# **APPLICANT'S RESPONSES TO ISSUES RAISED AT DEADLINE 8**

## **Drax Bioenergy with Carbon Capture and Storage**

Document Reference Number: 8.10.8

Applicant: Drax Power Limited

**Plate 3-1 - Schematic 1: Location of maximum cumulative hourly mean amines impact (Proposed Scheme plus Keadby 3). Indicative plumes shown in blue for wind direction B.**

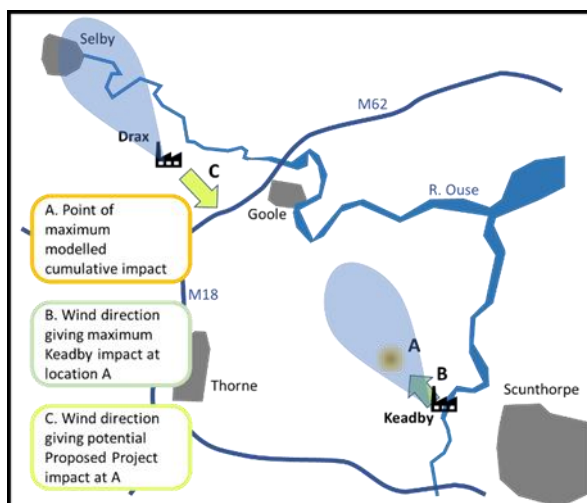
3.2.3. The maximum cumulative hourly mean impact occurs at the south-eastern extreme of the study area (location A in Schematic 1, close to Keadby) when the wind is blowing from the south-east i.e. from Keadby towards the study area (Direction B in Schematic 1). Under such conditions, the entire impact at A arises from Keadby alone since the contribution of the Proposed Scheme is precisely zero due to the location of maximum impacts being over 15km upwind of Drax.

3.2.4. At the point of maximum impact of the Keadby plume within the Proposed Scheme study area (i.e. the same location as for the maximum cumulative impacts, A in Schematic 1), the maximum potential impact from the Proposed Scheme would occur under north-westerly winds i.e. when the wind was blowing from the Drax Power Station (Direction C in Schematic 1). Under this wind direction, the contribution from Keadby at location A would be zero since it would be upwind of the Keadby power station.

3.2.5. There is, therefore, no potential whatsoever for cumulative impacts on hourly mean concentrations at locations between the Drax and Keadby Power Stations.

**Plate 3-2 - Schematic 2: Location of maximum hourly mean amines impact from Proposed Scheme alone. Indicative plumes shown in blue for wind direction C.**

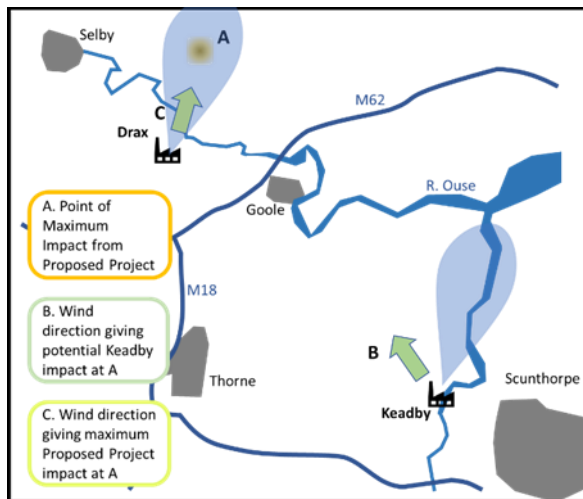
3.3.1. The maximum impact from the Proposed Scheme alone, neglecting amine degradation, is  $0.30\mu\text{g}/\text{m}^3$  as an hourly mean. This maximum impact occurs approximately 5km to north-north-east of Drax Power Station (location A in Schematic 2), when the wind is blowing from the south-south-west (Direction C in Schematic 2).

3.3.2. In the hour of maximum impact from the Proposed Scheme at location A, the impact from Keadby is imperceptibly small i.e.  $<10\ 10\mu\text{g}/\text{m}^3$ , since there is no significant overlap of plumes from Keadby and Drax under the required south-south-westerly winds.

3.3.3. The maximum cumulative hourly concentration at this location is  $0.44\mu\text{g}/\text{m}^3$ . This is significantly lower than the maximum hourly impact assessed in AQ TN1 ( $25.487\mu\text{g}/\text{m}^3$ ) and equates to the maximum impact from Keadby alone at this location i.e. the maximum impact at this location results from the impact of Keadby alone without the influence of overlapping plumes.

3.3.4. It can, therefore, be concluded that the potential for cumulative impacts to the north-east, or indeed south-west, of Drax Power Station is negligible i.e. the plumes simply will not overlap to any significant degree in this area.

**Plate 3-3 - Schematic 3: Location of potential cumulative impact. Indicative plumes shown in blue for wind direction B/C.**

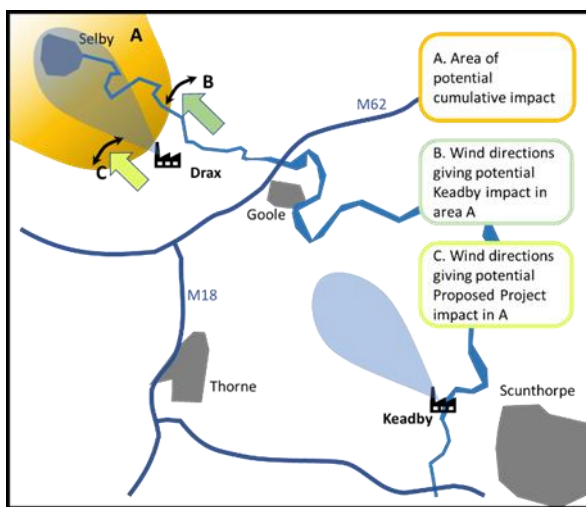
3.4.1. Given the distance separating Drax and Keadby Power Stations, the only realistic zone in which the plumes from Keadby and the Proposed Scheme could combine to produce a cumulative hourly mean impact in the same hour lies to the north-west of Drax (area A in Schematic 3) under south-easterly winds, or winds at least approximately aligned to south-easterly. This area of marginally enhanced cumulative impacts is apparent to a minor degree in a slight deviation to the generally

3.4.2. It has already been noted that the modelled impacts from Keadby far exceed those from the Proposed Project. With the area of potential cumulative impacts lying further from Keadby Power Station than the point of maximum impact (location A in Schematic 1), the maximum contribution from Keadby is much lower within area A than it was at its point of maximum impact. Whilst the impacts from Drax in area A are comparable to, but lower than, the maximum modelled impacts from Drax alone (at location A in Schematic 2), the potential cumulative impacts in this region are significantly lower than at the point of maximum cumulative impact nearer to Keadby.

3.4.3. For example, the maximum hourly mean impacts to the north-west of the Drax Power Station over Selby are, neglecting amine degradation:

Impact from Proposed Power Plant	0.00004 $\mu\text{g}/\text{m}^3$
Impact from Keadby Power Plant	0.371 $\mu\text{g}/\text{m}^3$
Cumulative Impact	0.371 $\mu\text{g}/\text{m}^3$

3.4.4. i.e. over 99.99% of the maximum cumulative impact arises from Keadby alone, even when the plumes overlap.

**Plate 4-1 - Spatial distribution of dispersion from stacks of 50m, 150m and 250m height in a neutrally stable atmosphere.**

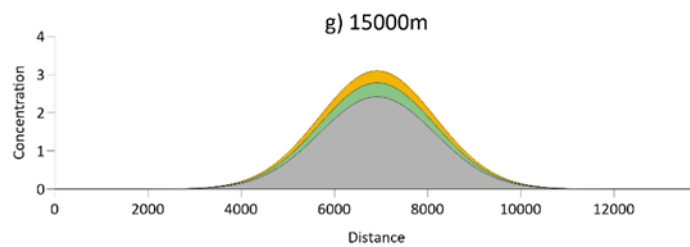
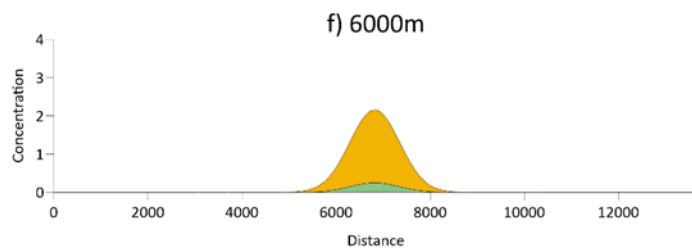
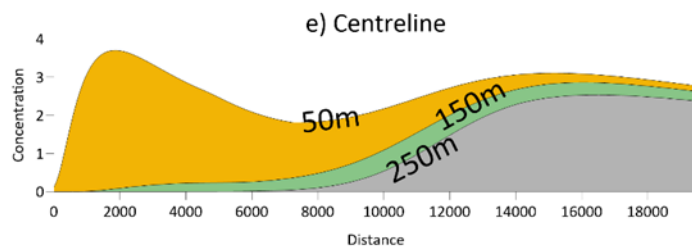
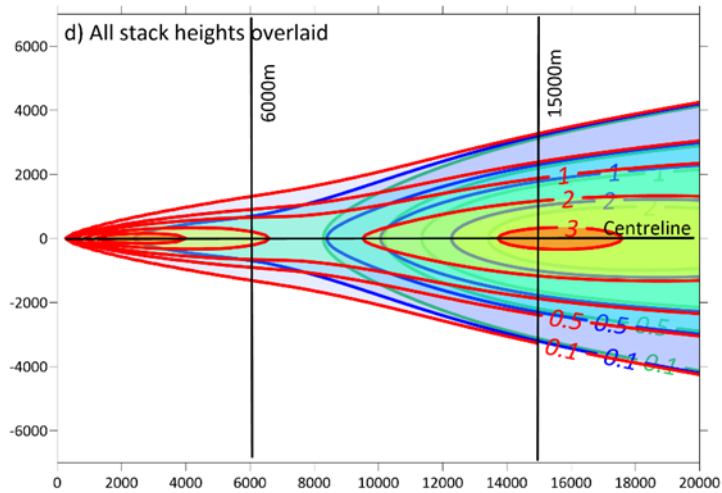
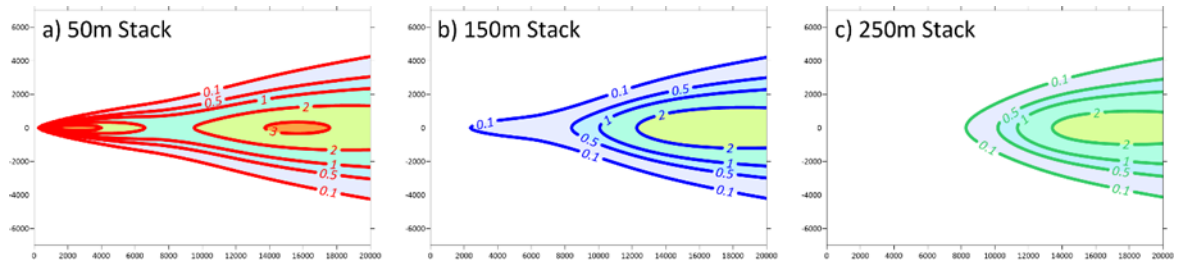
- At Response Ref 5.1 – “Drax’s emissions can be expected to disperse further because of its higher stack” (in comparison to a Norwegian study with lower stack)

- 4.1.3. To be clear, with the same exhaust parameters, the ground level impacts from a tall stack will be lower than or equal to the impacts from a lower stack at all distances downwind of the stack. It is incorrect to assert that emissions will be ‘dispersed further’ with the tall stack.

- 4.1.4. Figures 4-1 and 4-2 overleaf show examples of dispersion of pollutants from stacks of height 50m, 150m and 250m with a neutrally stable boundary layer (typical of cloudy and windy conditions) and an unstable boundary (typical of sunny conditions, with relatively light winds) respectively. The exhaust parameters are representative of Drax Power Station exhaust conditions but, for the purpose of this exercise, are arbitrary.

- 4.1.5. In these figures, Figures 4-1/4-2 a, b and c show the ground level footprint of the plume, where the x and y axes are the distances in metres down and cross wind respectively, for the stack heights of 50m, 150m and 250m. Figure 4-1/4-2 d shows the same spatial distributions overlaid on a single plot, to demonstrate that the envelope of the plume from each stack converges with distance downwind. Figure 4-1/4-2 e shows the evolution of ground level concentration along the plume centreline and Figures 4-1/4-2 f and g show cross sections of the ground level footprint at distances of 6000m and 15000m downwind of the stacks.

- 4.1.6. The following observations are made:
- The highest ground level concentrations are seen with the lowest stack height, at all distances downwind;

- The point of maximum impact moves downwind as the stack height increases, but the maximum concentration decreases with stack height, irrespective of the location of maximum impact;

- Ground level concentrations from all stack heights converge with distance downwind;
  - The horizontal extent of the plume from the various stacks converges for all stack heights with distance downwind; and

- The distance downwind into which the plume disperses is no greater for the tall stack than the short stack.
- 4.1.7. The explanation for these observations is that:

- 4.2.1. It is illogical to assert that the high stack at Drax Power Station is anything other than a benefit for the dispersion of pollutants from the Proposed Scheme. This applies at all distances downwind.
